| type MET-ALL | Title Speed Indicator for MET Turbocharger | Ref Tz - M3549 |
| | | Date 22nd May, 2007 |

2. Content of modification:

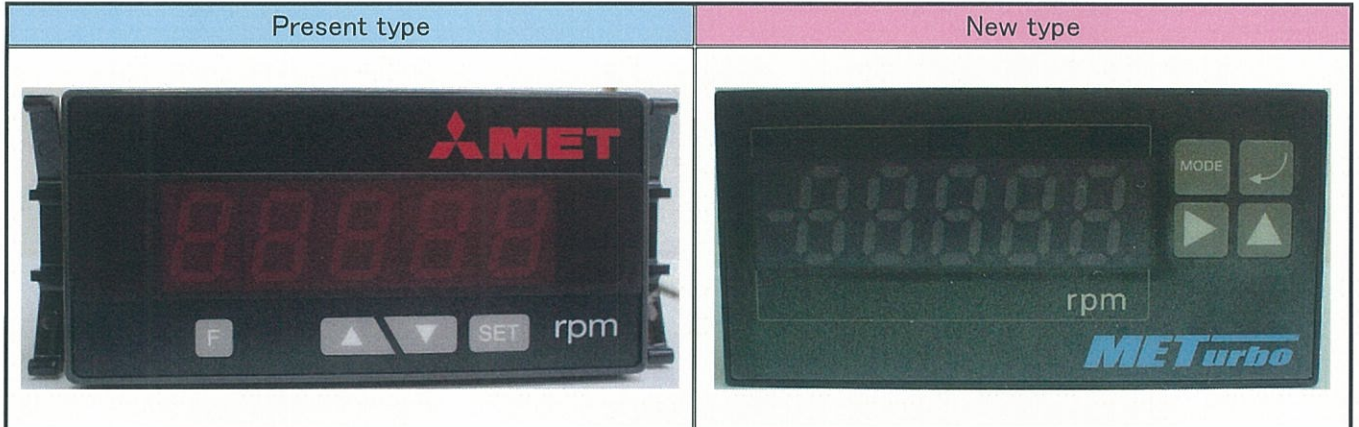
As for the connection between the speed indicator and junction box for Turbocharger, rear port of speed indicator was simplified in order to improve reliability, considering the convenience in use.

Present type: 73R-AC-C, 73R-DC-C

New type: 73RS-AM, 73RS-DM

- ※ The modification and the wiring methods for new and present type speed indicators are shown on the attached drawing. The main modifications are the terminal arrangement for rear port and connecting methods.
- ※ The indicator function was not changed but operation methods were changed a little. As for the detail, please refer to the instruction manual.
- ※ The panel dimension was not changed.

The new indicator can be used with the present junction box and sensor probe. There is compatibility between present and new indicator. (Only wiring shall be changed.)

3. External view

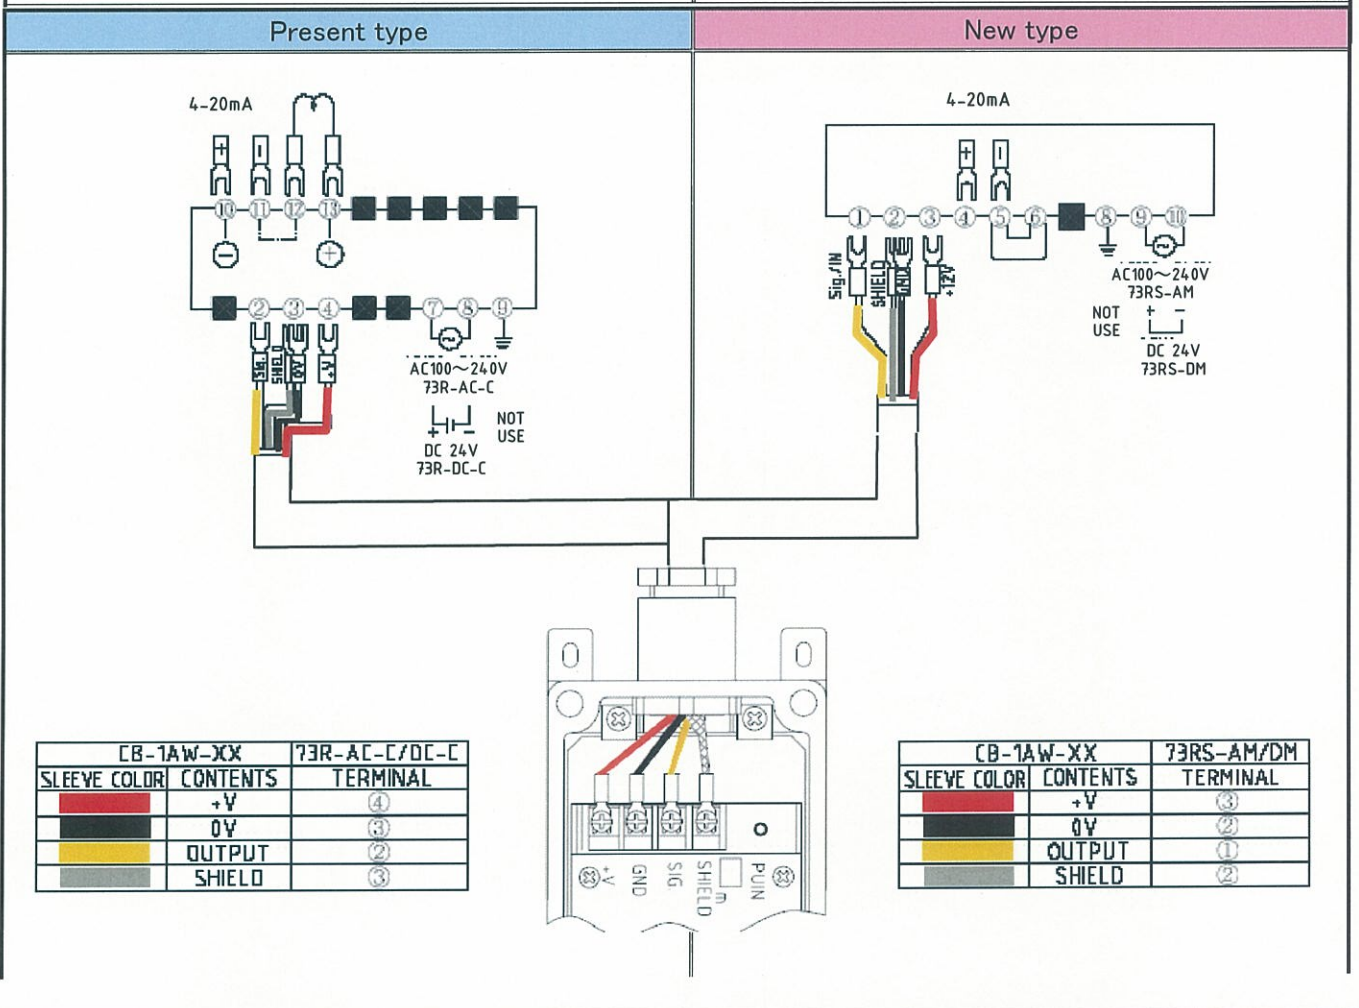
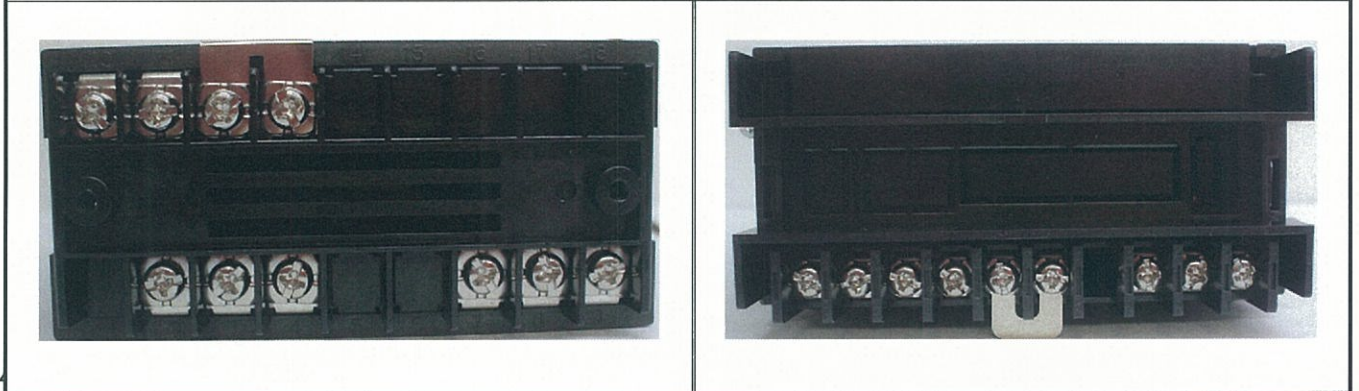
1. Subject type: Speed indicator (As for the detail, please refer to the page 2)

CAUTION

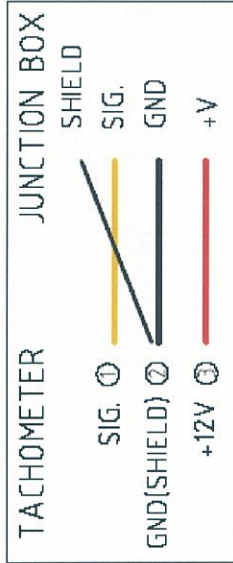
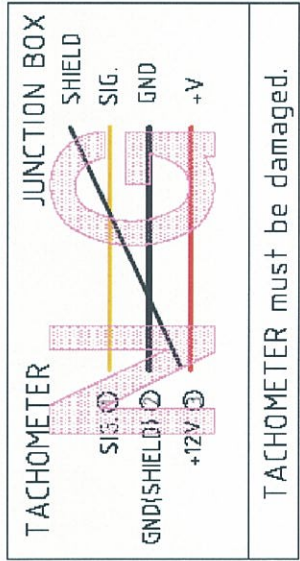
Besides, the caution document for wiring between speed indicator and junction box will be enclosed in the indicator box to avoid faulty wiring for the tachometer. (Please refer to the page 3)

Wrong cable connection may cause JUNCTION BOX and TACHOMETER damaged.
Some typical examples are shown as follow.

TACHOMETER must be damaged.

The correct wiring
